MAYWOOD, IL.
9th AVE
M.P.10.70
GENEVA SUB.

MAYWOOD, ILLINOIS
9TH AVE.
M.P. 10.70
GENEVA SUBDIVISION
D.O.T.#174 001M

CHICAGO, ILLINOIS
TO CLINTON, IOWA
C.T.C. CIRCUITS

DATE 09-07-05
SHEET 2
DWG 10.70
GEN

ID=GEN01070.00C

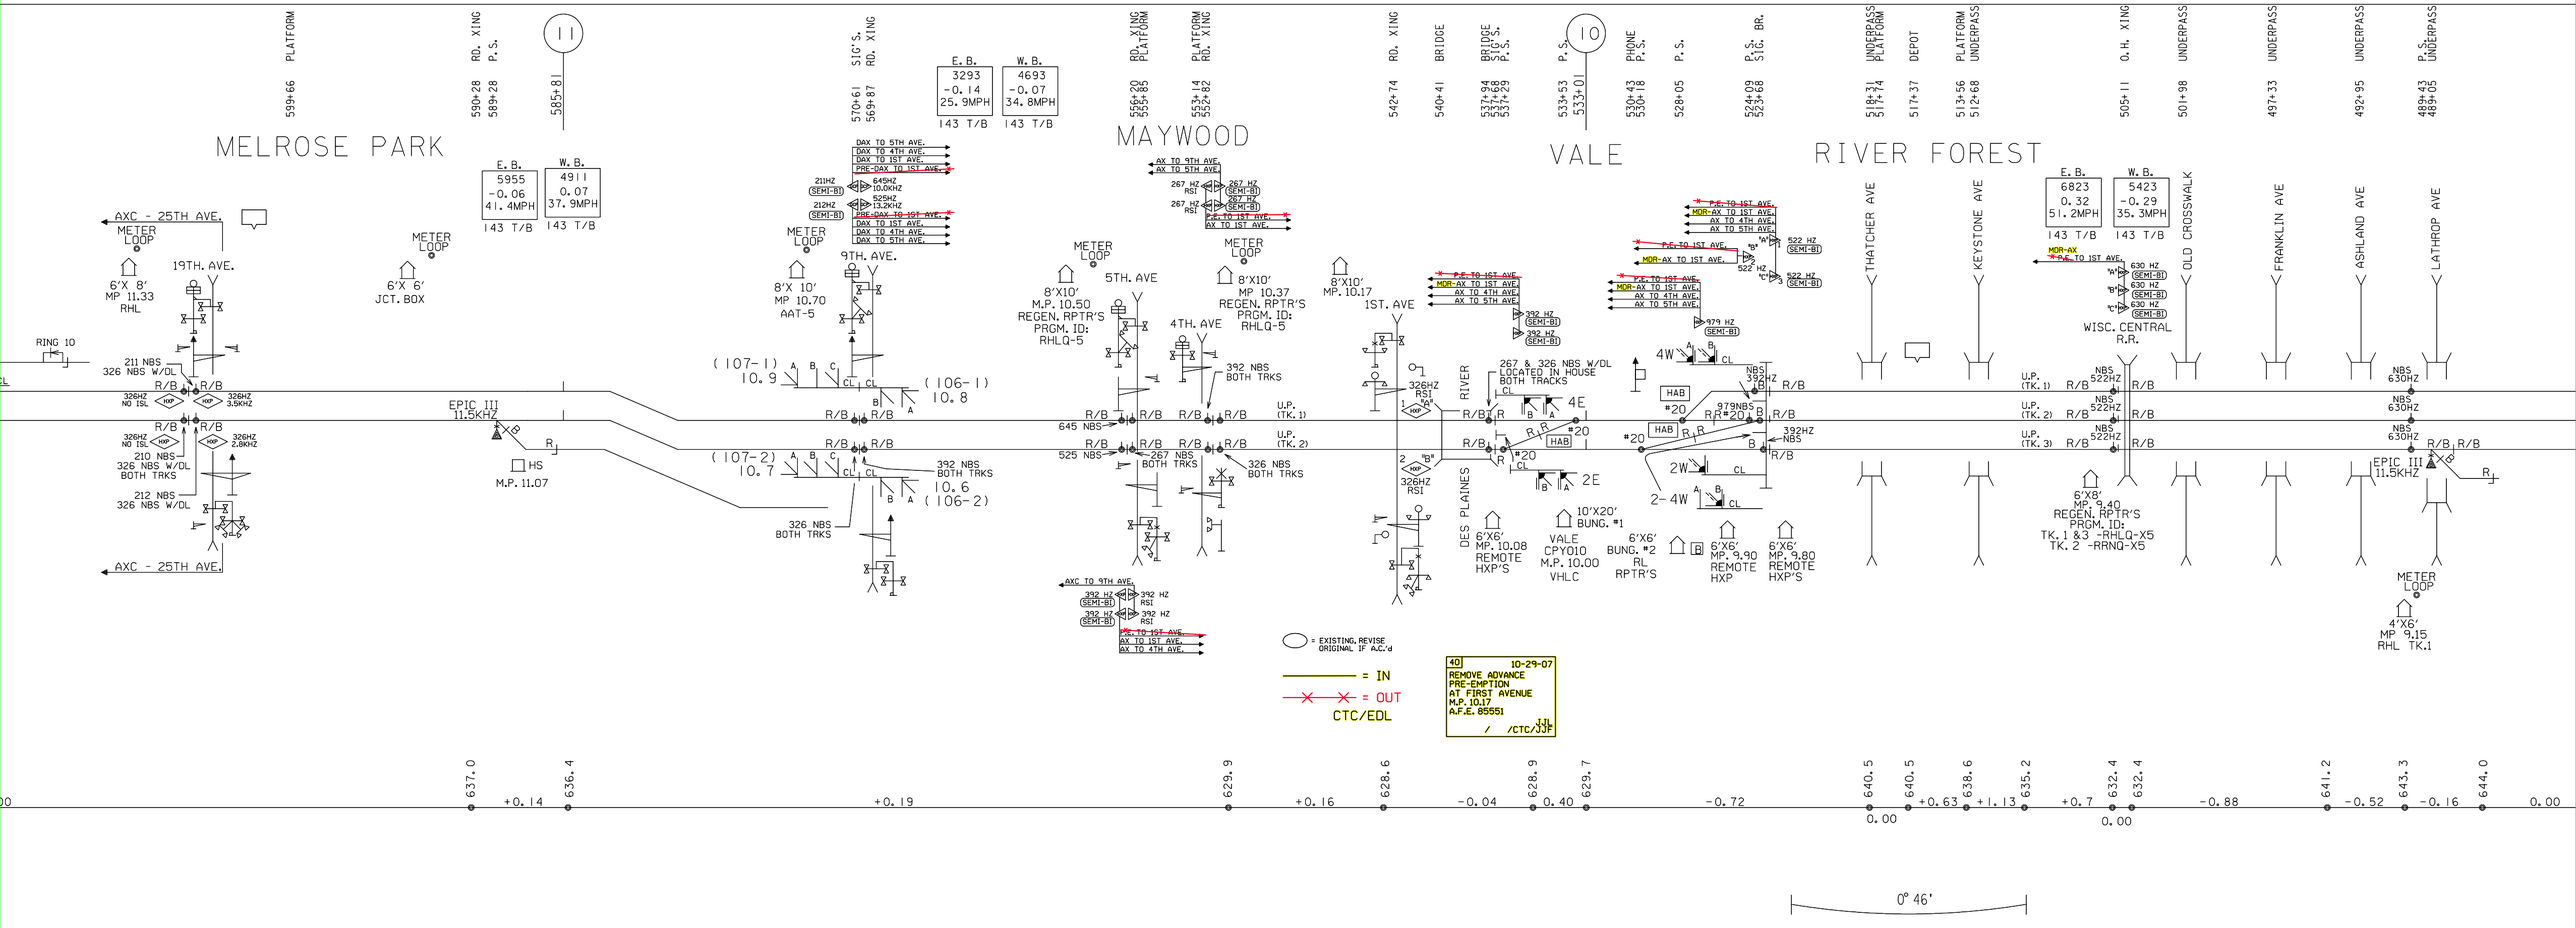
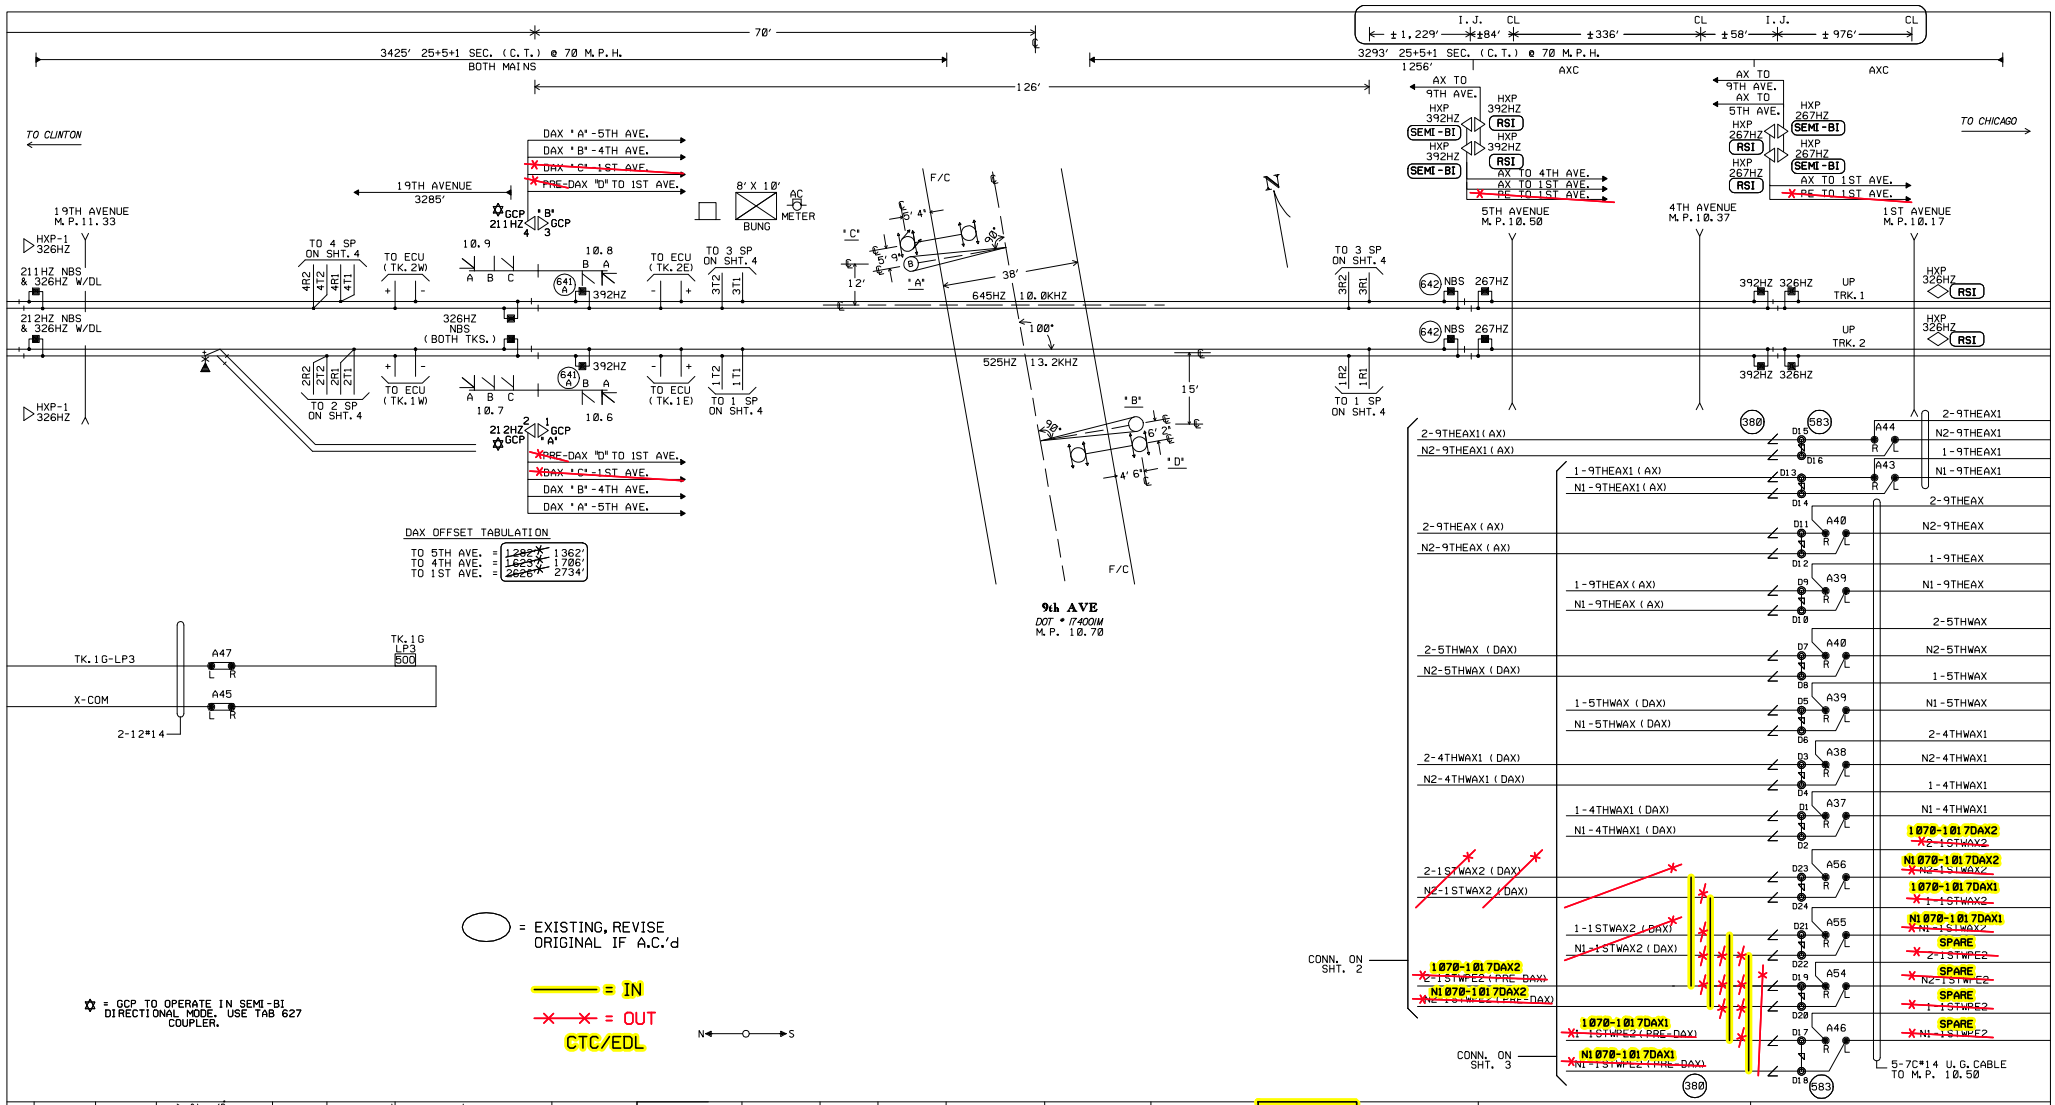
10.6 (106-2)
392 NBS BOTH TRKS
326 NBS BOTH TRKS
8'X10' M.P. 10.50 REGEN. RPTR'S PRGM. ID: RHLQ-5
5TH. AVE
4TH. AVE
8'X10' MP 10.37 REGEN. RPTR'S PRGM. ID: RHLQ-5
8'X10' MP. 10.17
1ST. AVE
645 NBS
525 NBS
267 NBS BOTH TRKS
326 NBS BOTH TRKS
U.P. (TK. 1)
U.P. (TK. 2)
DES PLAINES RIVER
267 & 326 NBS W/DL LOCATED IN HOUSE BOTH TRACKS
6'X6' MP. 10.08 REMOTE HXP'S
10'X20' BUNG. #1
VALE CPY010 M.P. 10.00 VHLC
6'X6' BUNG. #2 RL RPTR'S
6'X6' MP. 9.90 REMOTE HXP
6'X6' MP. 9.80 REMOTE HXP'S
THATCHER AVE
KEYSTONE AVE
OLD CROSSWALK
FRANKLIN AVE
ASHLAND AVE
LATHROP AVE
WISC. CENTRAL R.R.
6'X8' MP. 9.40 REGEN. RPTR'S PRGM. ID: TK. 1 &3 -RHLQ-X5 TK. 2 -RRNQ-X5
EPIC III 11.5KHZ
4'X6' MP 9.15 RHL TK.1
= EXISTING, REVISE ORIGINAL IF A.C.'d
= IN
= OUT
CTC/EDL
40 10-29-07
REMOVE ADVANCE PRE-EMPTION AT FIRST AVENUE M.P. 10.17 A.F.E. 85551
JJL
/CTC/JJF

14 10-29-07
REMOVE ADVANCE
PRE-EMPTION
AT FIRST AVENUE
M.P.10.17
A.F.E. 85551
/ /CTC/JJF

DES: CTC
DIG: CTC
CHK: RLT
A.F.E.
ID= GEN01070.2X

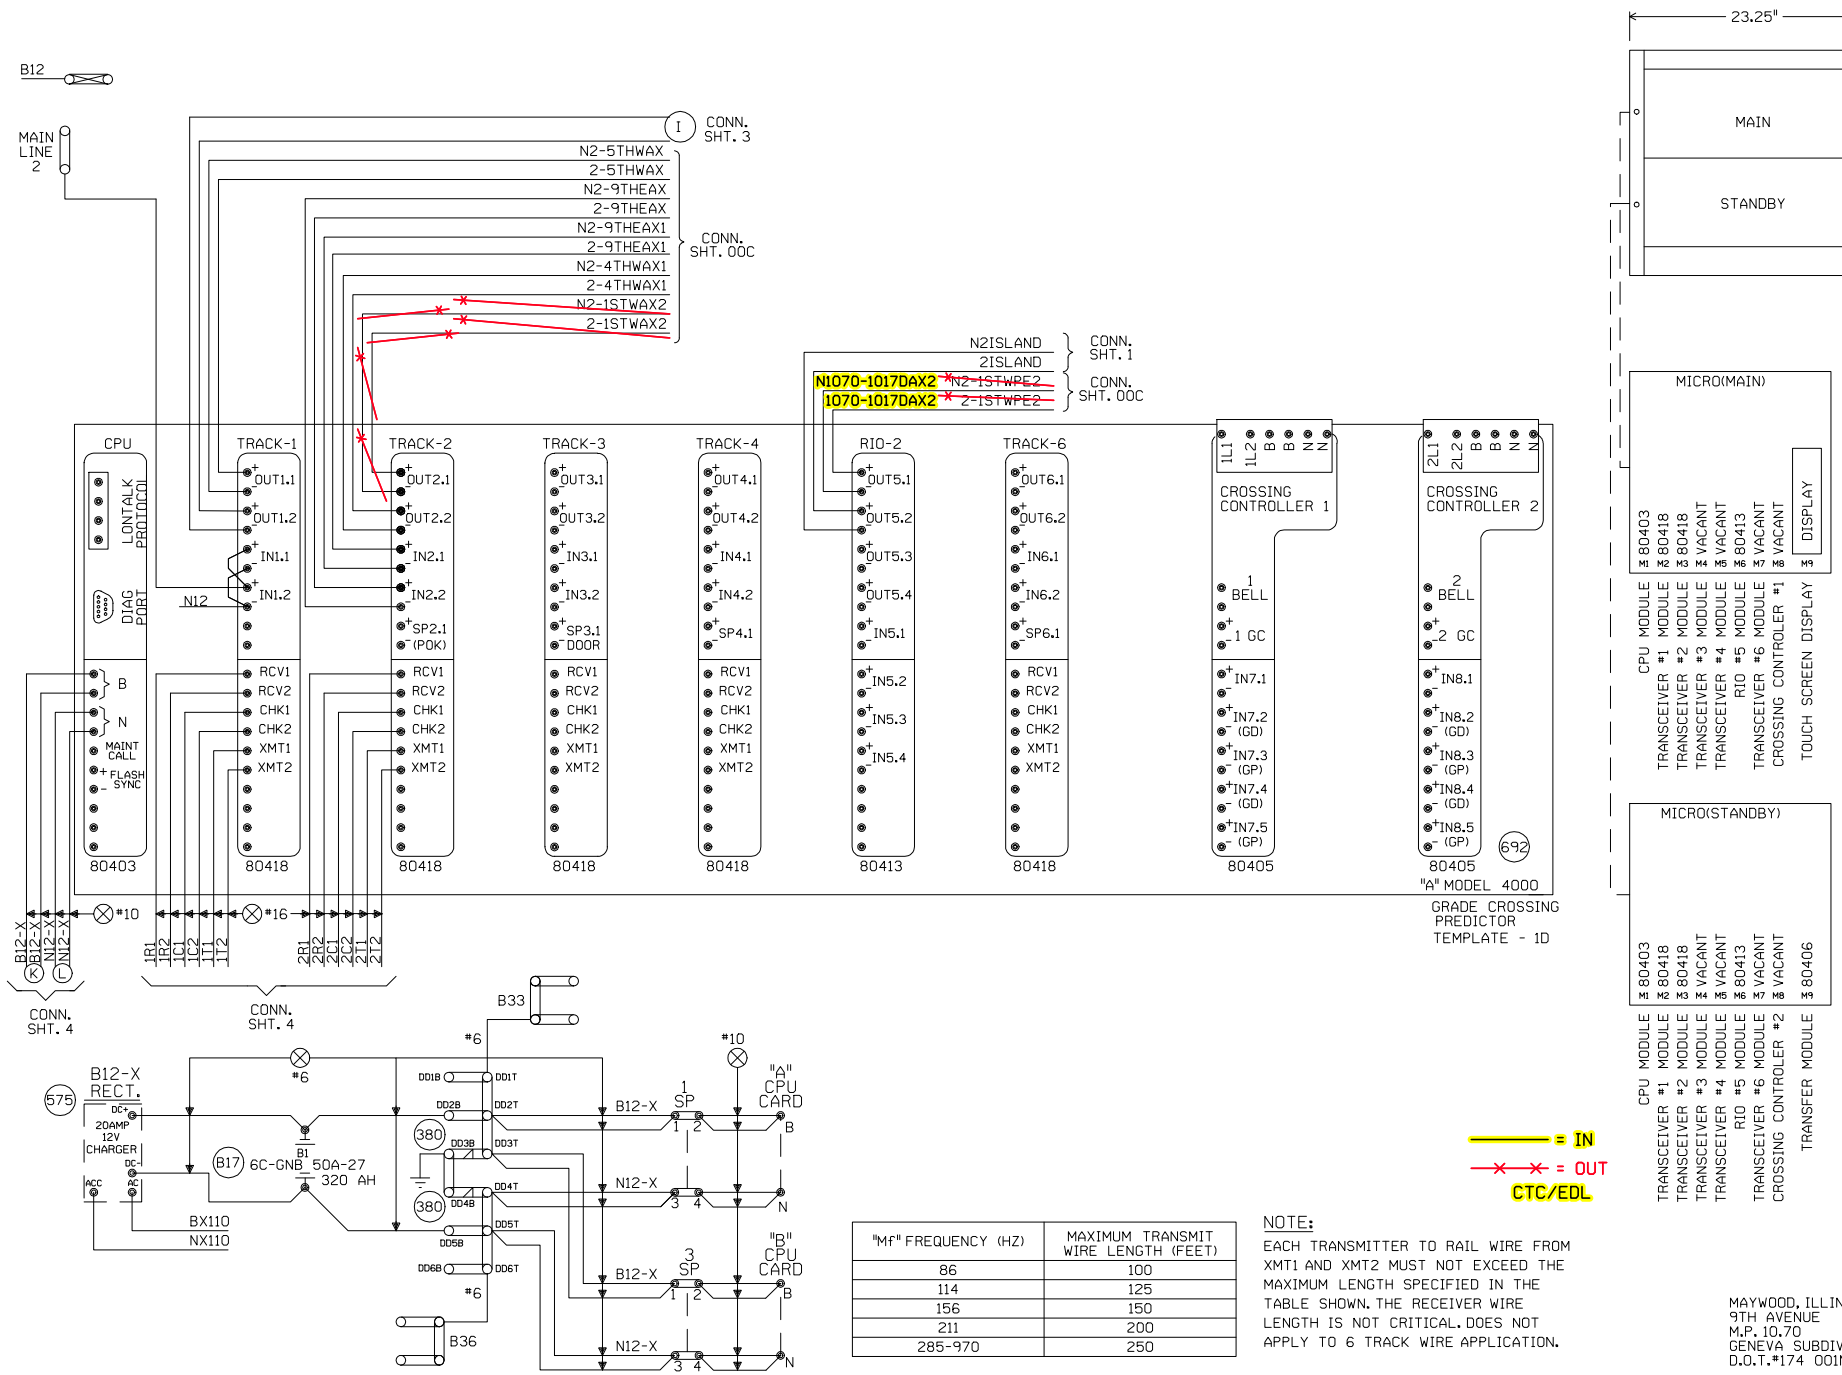
3	10-29-07	REMOVE ADVANCE PRE-EMPTION AT FIRST AVENUE M.P. 10.17 A.F.E. 85551 JJL / /CTC/JJF
REV. 9-23-08 INSTALLED CROSSING CONTROLLER CARDS TO EXISTING GCP 4000 AT 9TH AVENUE. REC. #15247 6-2-08 RLT TH/WITT/CTC/RDD		
REV. 9-23-08 REPLCAED HXP-1 WITH A GCP 4000 AT 9TH AVENUE M.P. 10.70 W.O. #60735 REC. #15247 6-2-08 RLT TH/WITT/CTC/RDD
